PLANNING AND DEVELOPMENT ACT 2007

SECTION 197 AMENDMENTS

PROJECT
MERITON SUITES CANBERRA
40 ALLARA ST
CANBERRA ACT 2061

DRAWING TITLE
COMPOSITION ELEVATIONS - NORTH AND WEST

01 WEST ELEVATION

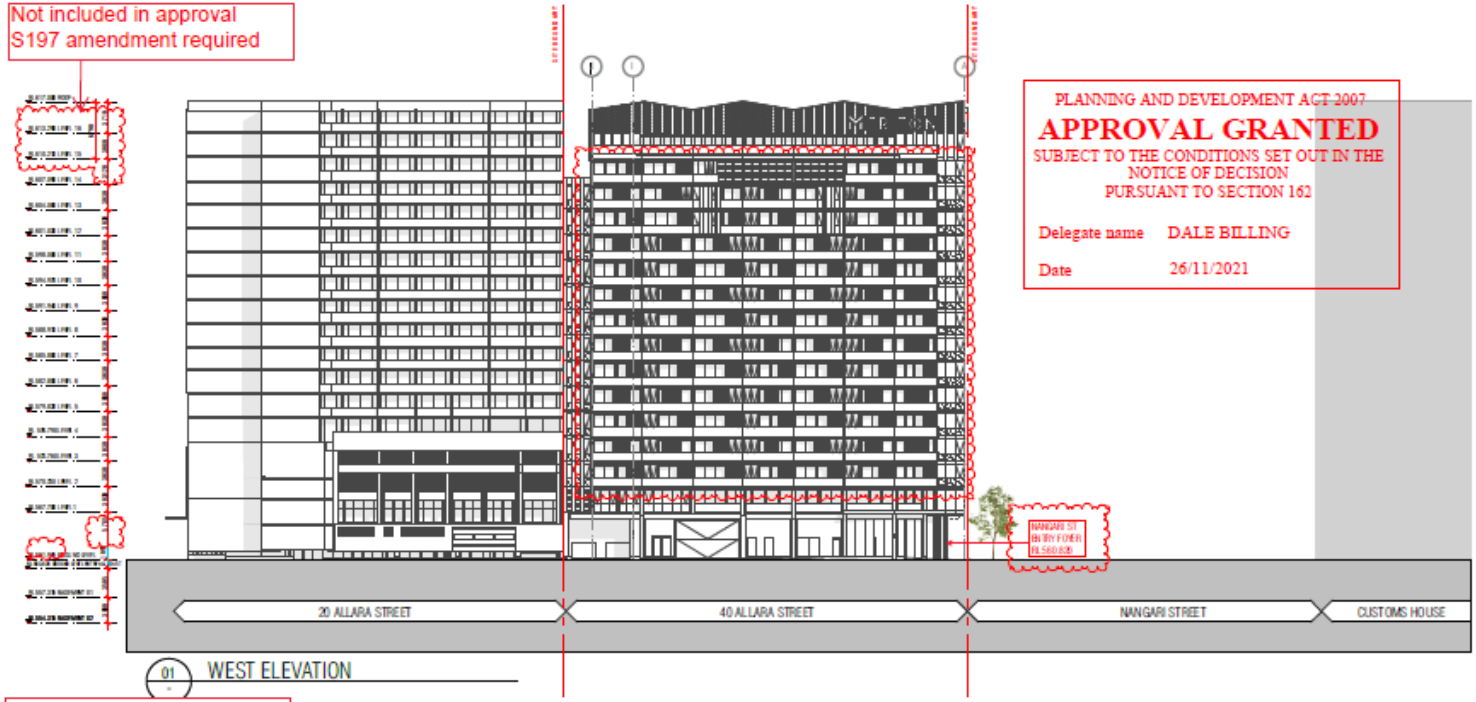
Not included in approval
S197 amendment required

1. Floor Plan Amendments
Fire egress passages to exit onto Nangari Street
Substation footprint increase as per Evoenergy requirements
Ground Level Loading Dock, Level 15, 16 FFL/SSL change.
2 x class 3 bicycle racks moved from unleased land to within site boundary
Retail tenancies sqm adjustments and tenancies 02 and 03 combined into one.
Deletion of ground level external planter box to Allara Street
Hotel suite 301 made accessible in lieu of suite 215 due to structural column impacting circulation clearances
Roof level 17 opening to level 16 below removed. Roof is fully enclosed

4. GFA Adjustments - general update
5. Façade Treatment
Rabaul Lane awning reduced in length due to substation height clearance requirements
Nangari Street awning increase in depth
Lv6 shading elements added to western facade
Frosted privacy glass to transom height south façade and partial east and west facades
Nangari Street hotel entry automatic sliding door in lieu of revolving door
Allara Street removal of one side exit door swing door
Shop front glazing G2 clear glass
Shop front glazing increased panel width to retail tenancy 02
Driveway carpark entry swing doors in lieu of panel lift overhead garage door

02 NORTH ELEVATION

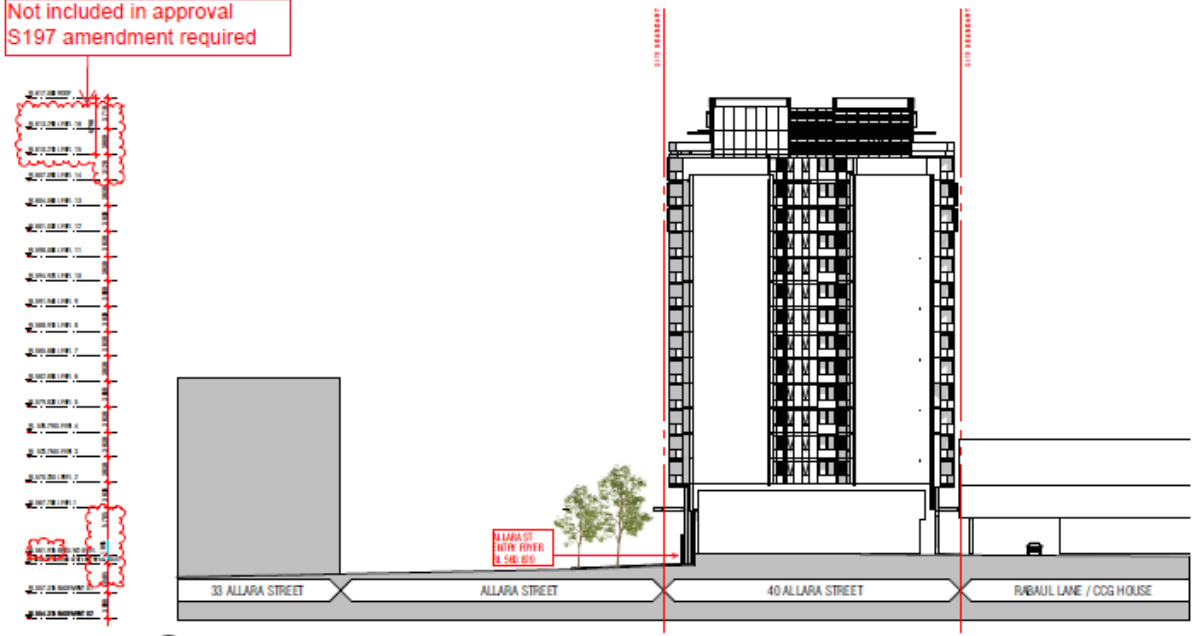
Not included in approval
S197 amendment required

01 - EAST ELEVATION

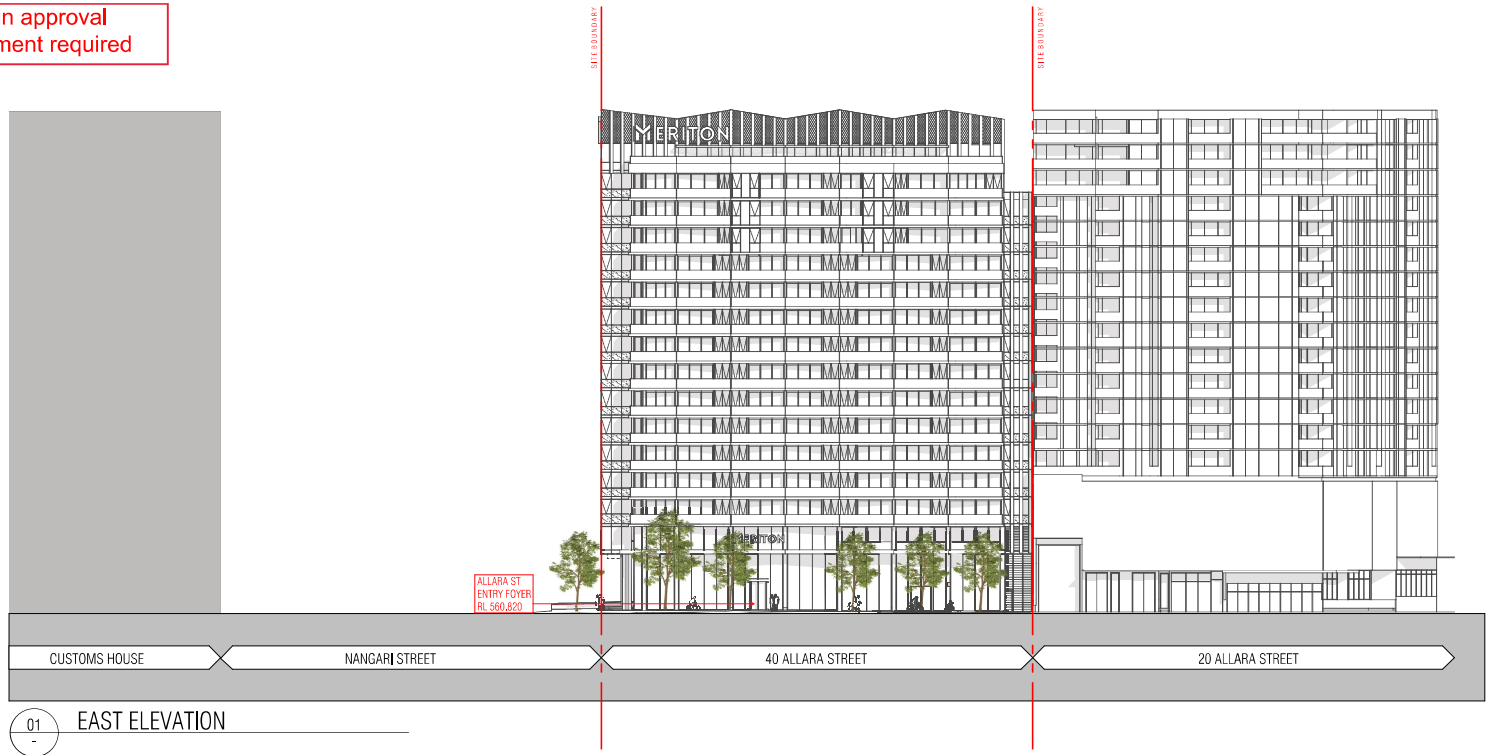
Not included in approval
S197 amendment required

02 - SOUTH ELEVATION

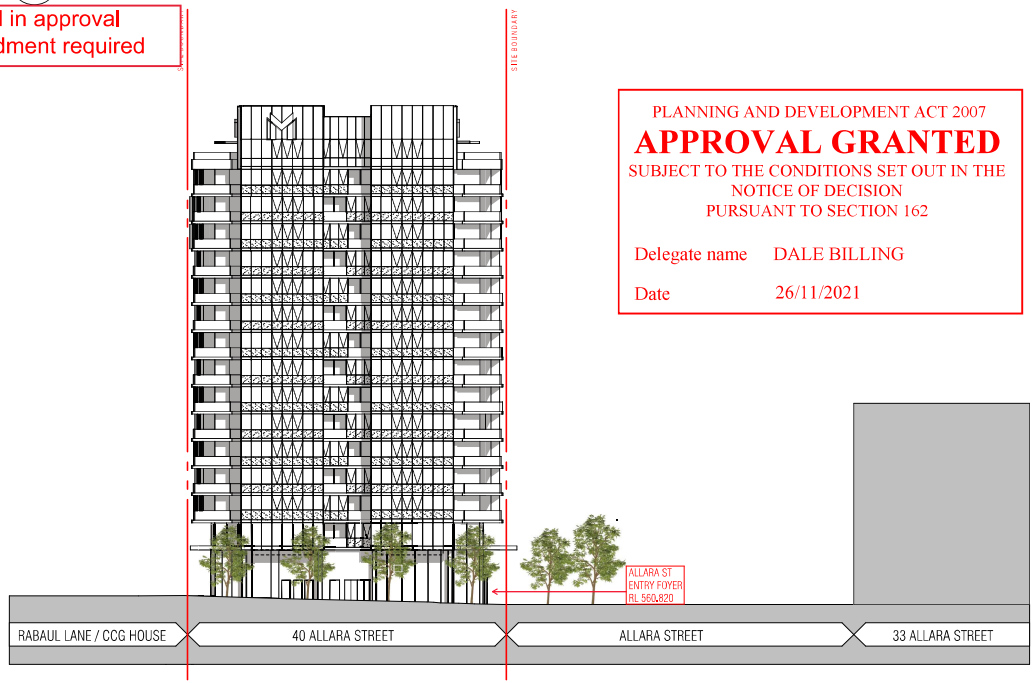
Not included in approval
S197 amendment required

AA
-

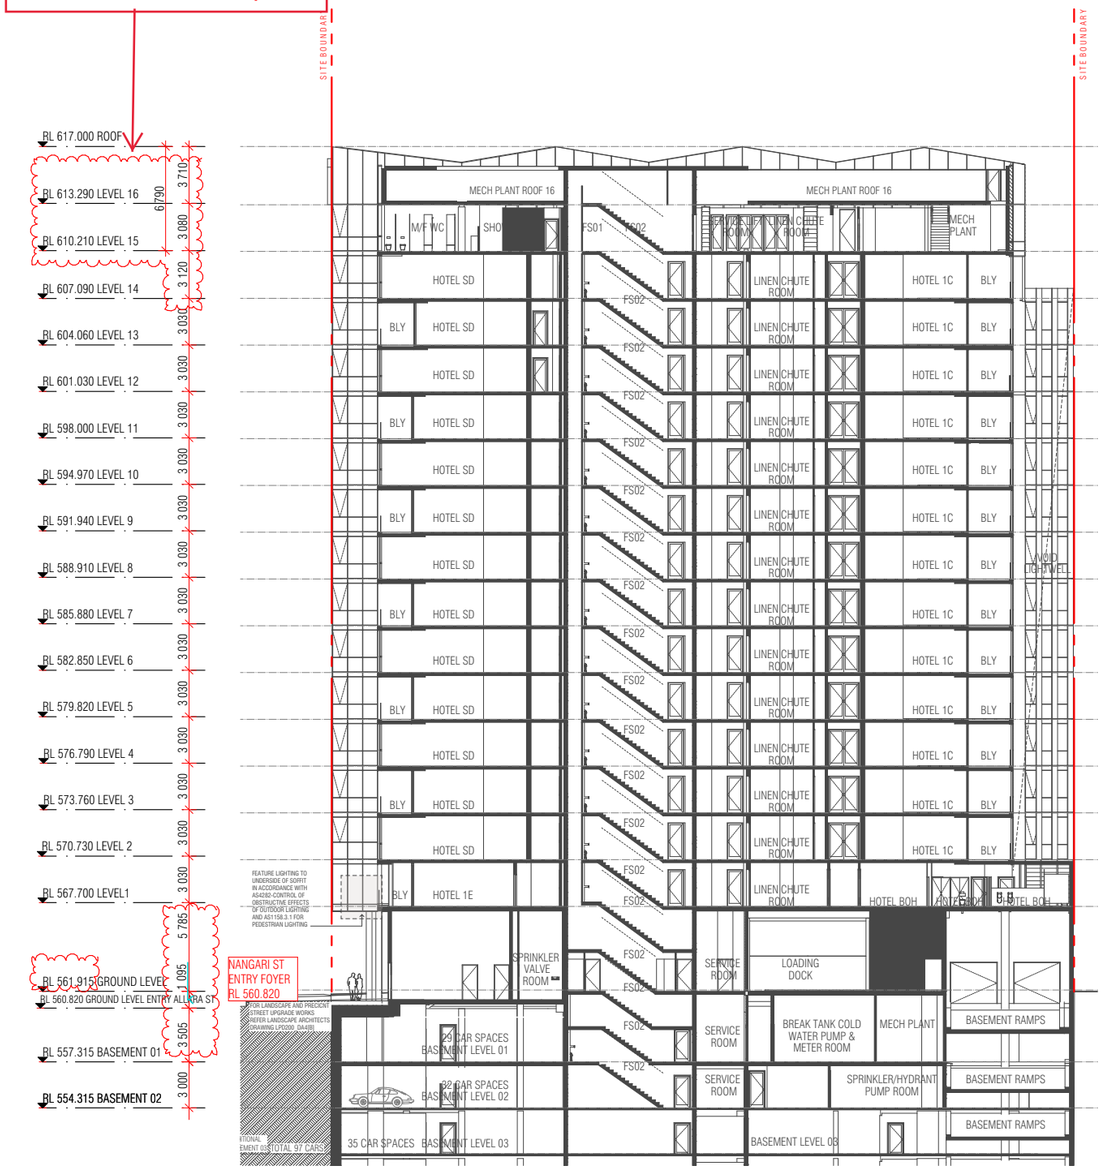
Not included in approval
S197 amendment required

BB
-

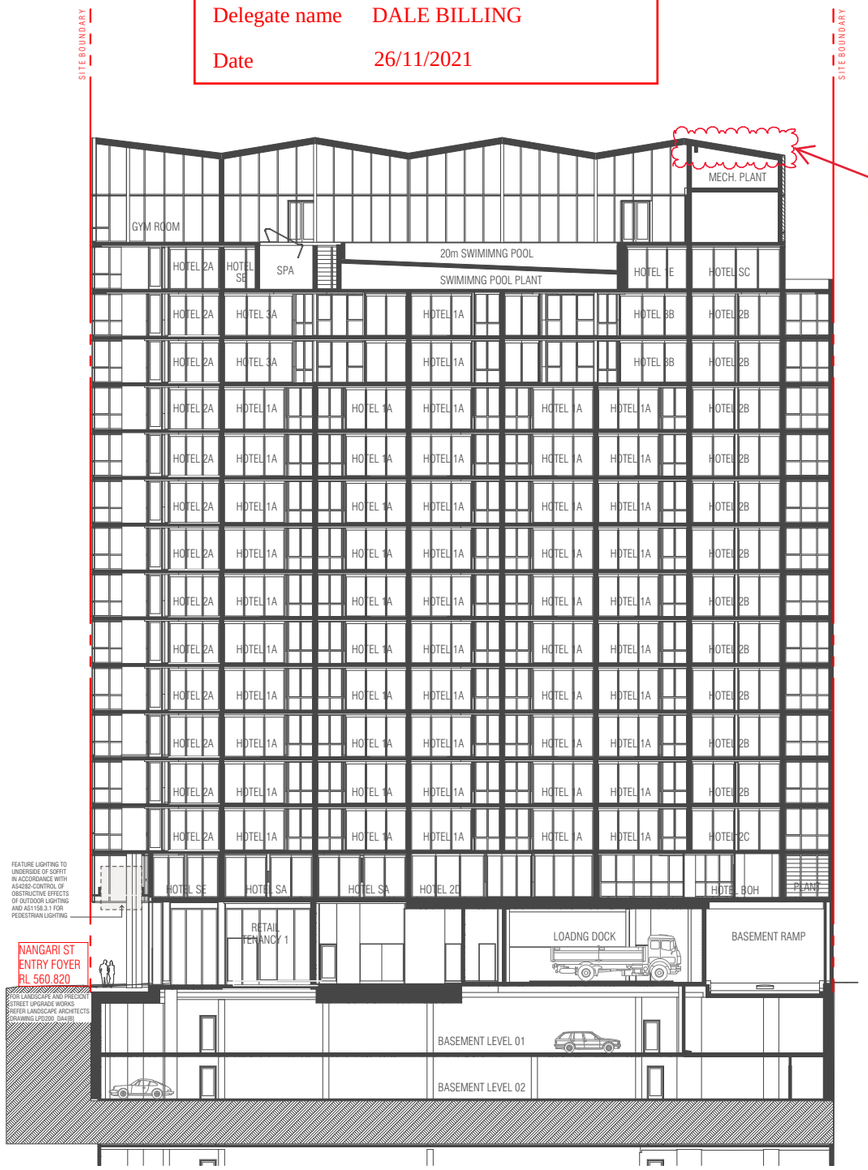
Not included in approval
S197 amendment required
